Item ID: D407-667-105 Accept *N900040100* Setup Start *NS1*
Revision ID: Stop *NS2*
Item Name: Fwd Crosstube - High 407
Start Date: 6/29/2015 Start Qty: 1.00 *1* Cust Item ID:
Required Date: 6/29/2015 Req'd Qty: 1.00 *1* Customer:
Reference:

DRAWING NO. D407-667-145	TITLE CROSSTUBE ASS'Y (407 HIGH FWD)	REV. C	DART AEROSPACE LTD ENGINEERING ORDER		D.E.O. NO. D407-667-145-C-1	SHEET NO. SHEET 1 OF 1	SCALE NTS
DRAWN <i>qp</i>	CHECKED <i>ASS</i>	MFG. APPR. <i>IB</i>	APPROVED <i>WD</i>		DE APPR. <i>#</i>		
DATE 11.07.15	DATE 11.07.22	DATE 11.07.22	DATE 11/07/22		DATE 11.07.21

DRAWING NO. D407-667-145	TITLE CROSSTUBE ASS'Y (407 HIGH FWD)	REV. C	DART AEROSPACE LTD ENGINEERING ORDER	D.E.O. NO. D407-667-145-C-2	SHEET NO. SHEET 1 OF 1	SCALE NTS
DRAWN AJS	CHECKED [Signature]	MFG. APPR. [Signature]	APPROVED [Signature]	DE APPR. [Signature]		
DATE 12.08.02	DATE 12.08.02	DATE 12.08.02	DATE 12.08.02	DATE 12.08.02

DETAIL P
BONDING STRAP INSTALLATION 2 PL

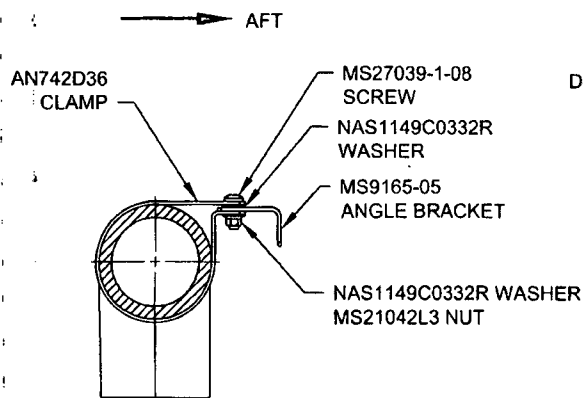
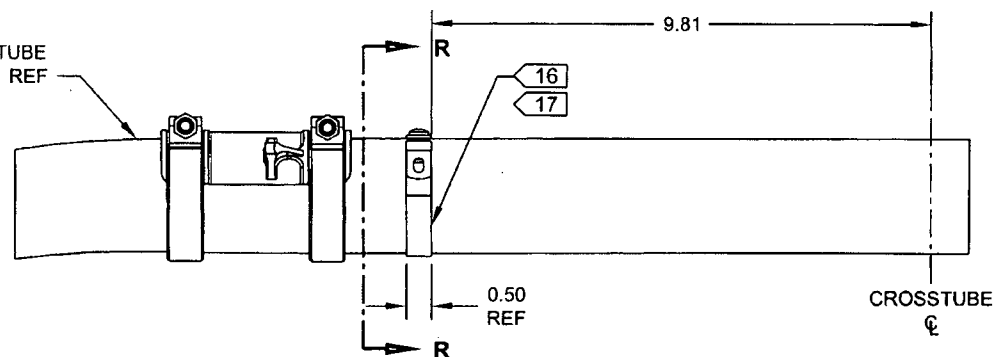
PURPOSE:

ADD ELECTRICAL GROUNDING STRAP

ITEM	QTY -145	PART NUMBER	DESCRIPTION
1	X	D407-667-145	CROSSTUBE ASSEMBLY (407 HIGH FWD)
10	2	AN742D36	CLAMP
11	2	MS9165-05	ANGLE BRACKET
12	2	MS21042L3	NUT (OR MS21042-3)
13	2	MS27039-1-08	SCREW
14	4	NAS1149C0332R	WASHER (OR AN960C10L)

- 16) MASK AREA UNDER CLAMP PRIOR TO PAINTING
- 17) SEAL EDGES WHERE AN742D36 CLAMP MEETS WITH THE CROSSTUBE USING SIKAFLEX-241/-291 OR MIL-S-8802 CLASS B2 OR PROSEAL 890 SEALANT
- 18) PERFORM RESISTANCE CHECK TO ENSURE MAX RESISTANCE IS 10 MILLIOHMS
